KIRKSVILLE REGIONAL AIRPORT KIRKSVILLE, MISSOURI MODOT PROJECT NO. 24-028A-1

ADDENDUM NO. 3 TO

CONTRACT DOCUMENTS, SPECIFICATIONS AND PLANS FOR IMPROVEMENTS TO THE KIRKSVILLE REGIONAL AIRPORT KIRKSVILLE, MISSOURI MODOT PROJECT NO. 24-028A-1

A GEOMETRY PLAN - TERMINAL

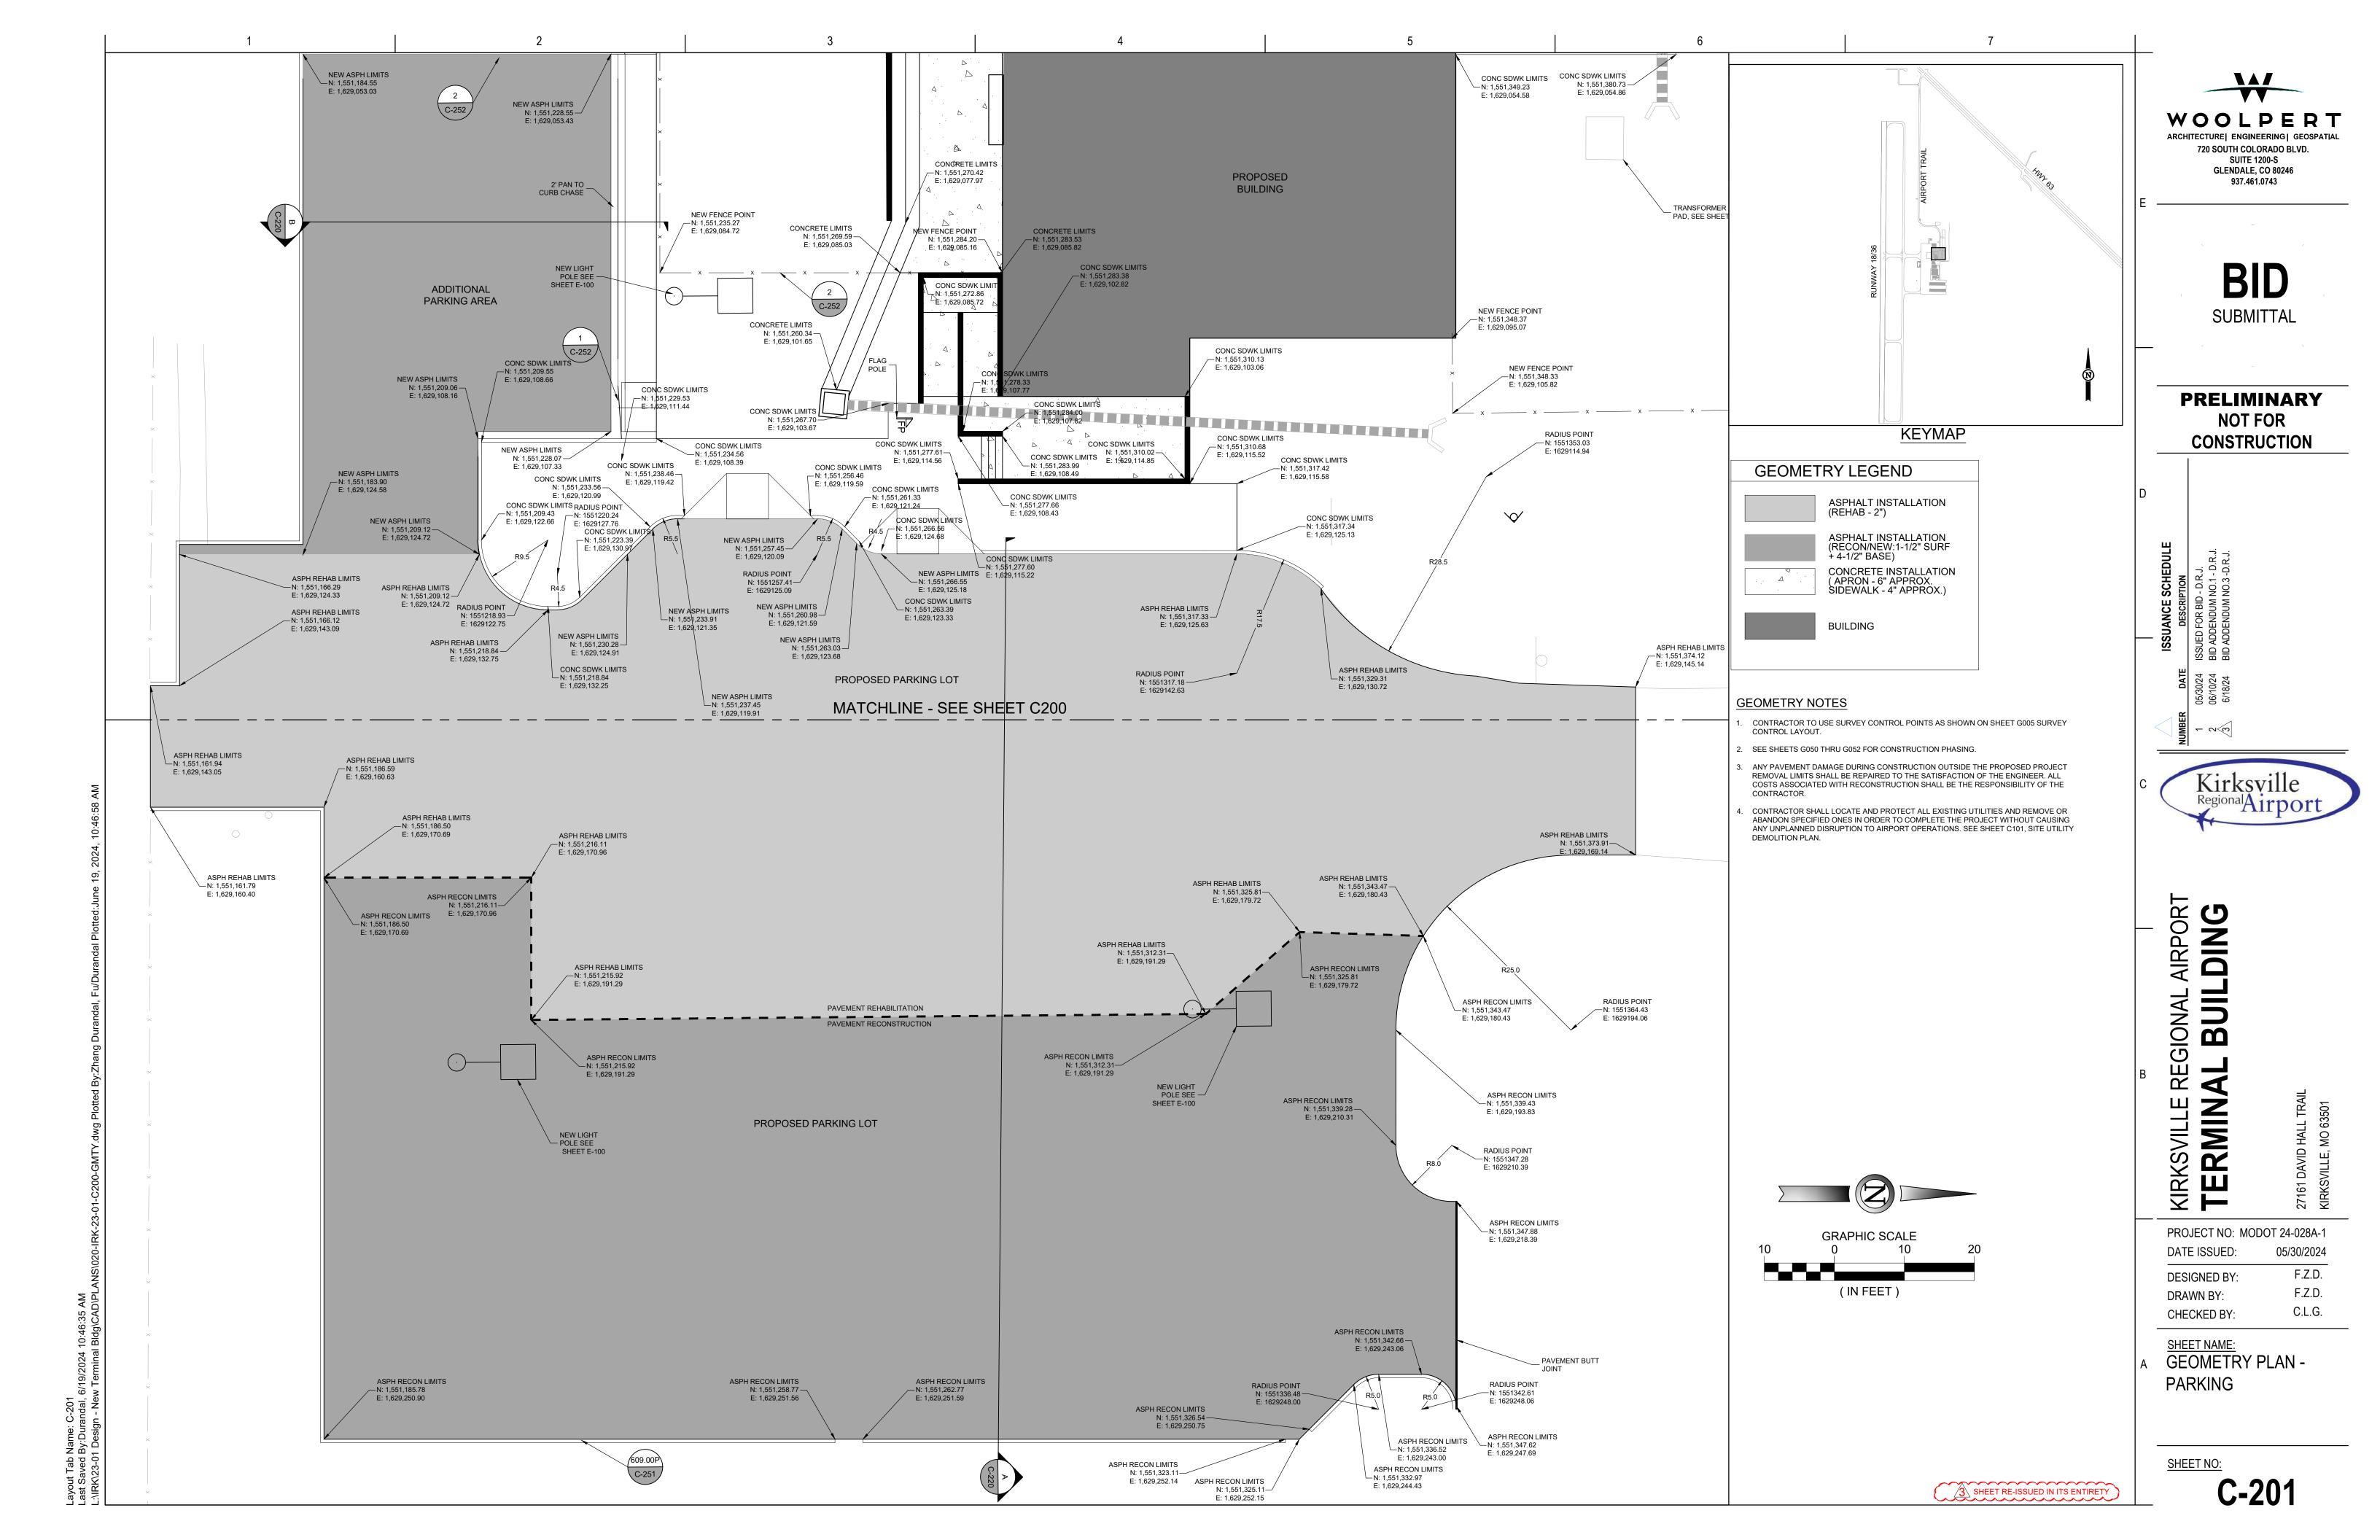
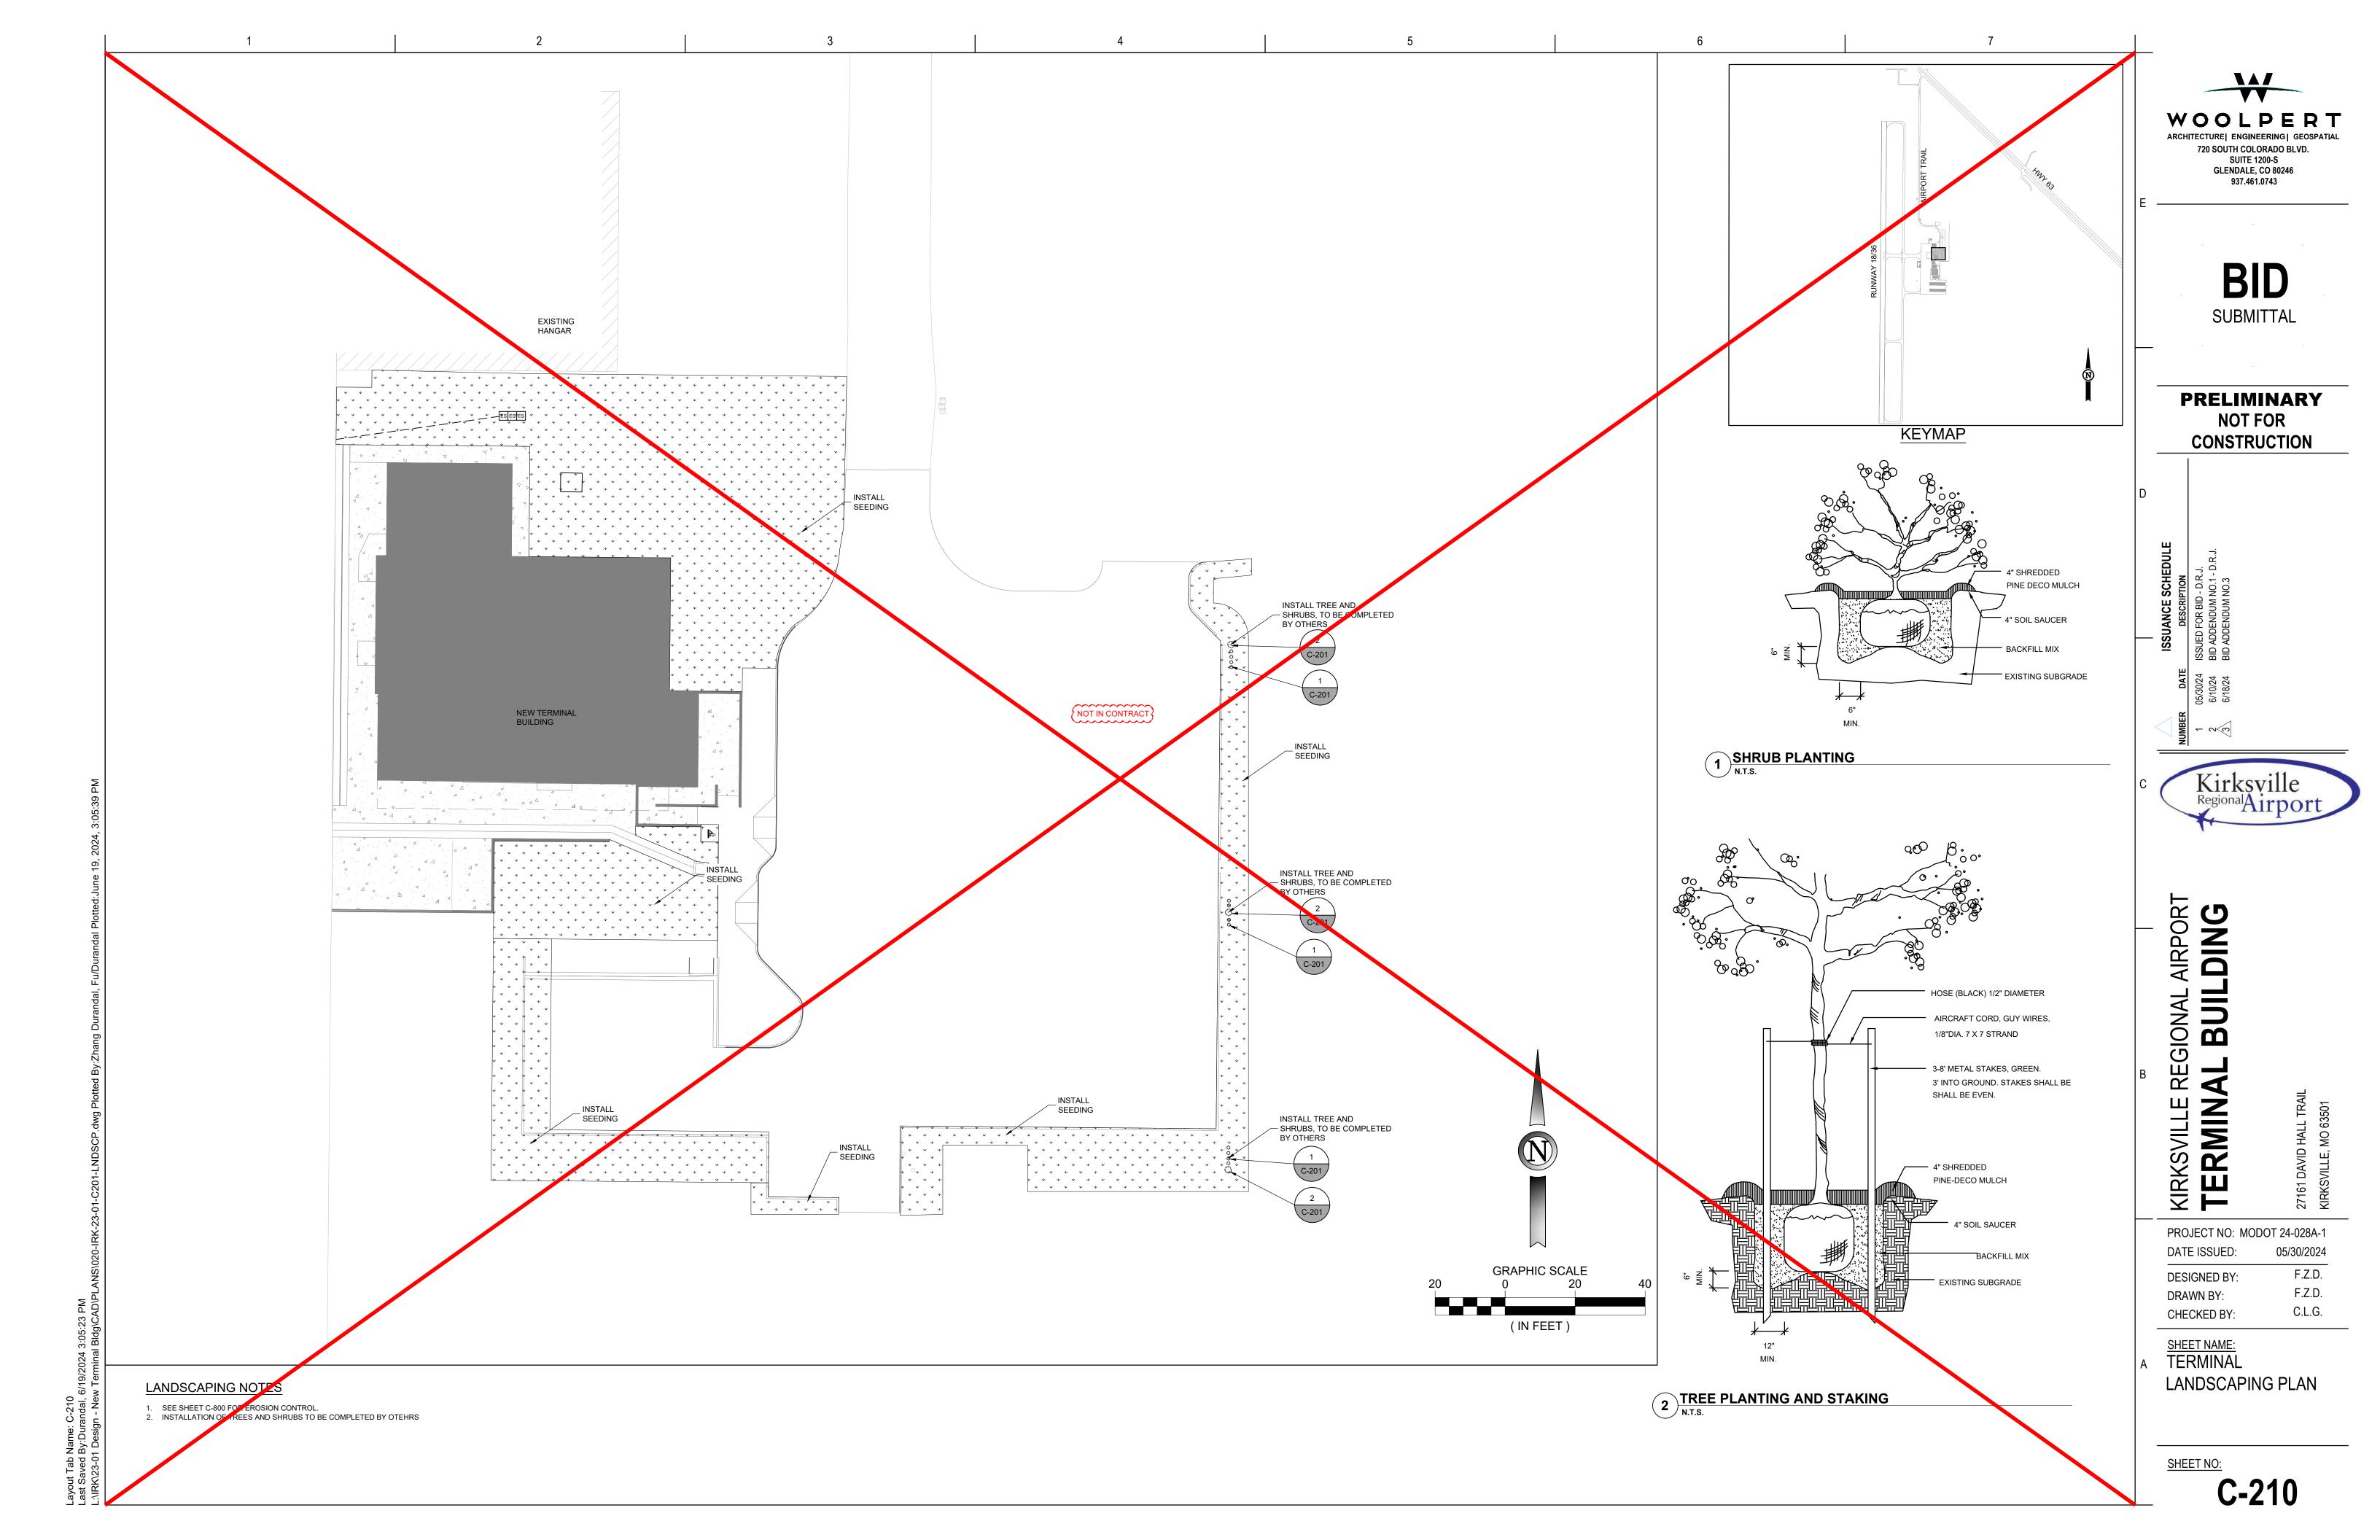
Revision: Modified ADA parking area to include ramps and curb. Modified east parking lot area to

include curb and gutter. **Justification:** For clarity.
